Received from Chief Ship Surveyor

SHIP'S NAME

St S. Alda

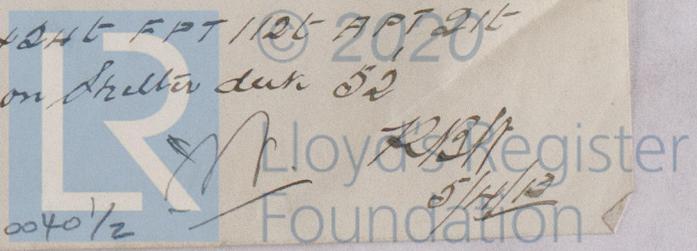
This vessel appears to have been built in accordance with the Rules and the approved plans, and it is submitted she is eligible to be classed + 100 A1. (Steel) "Shelter deck with freeboard," as recommended. The Summer freeboard of 5' 0 1/2" from centre of disc to top of statutory deck line at upper deck, now marked on the vessel's sides, to be inserted in the classification certificate, and recorded in the Register Book, and further, the remaining freeboards, as shown on the accompanying verification form to be inserted in the certificate of classification.

It is concluded that the thickness of the tank top
middle line strake is .54 & not .44 as reported
but the Surveyor should state if this is so, & he should
be informed that the vessel's class is 100 A1 Shellin
deck with foreboard & not as reported by him
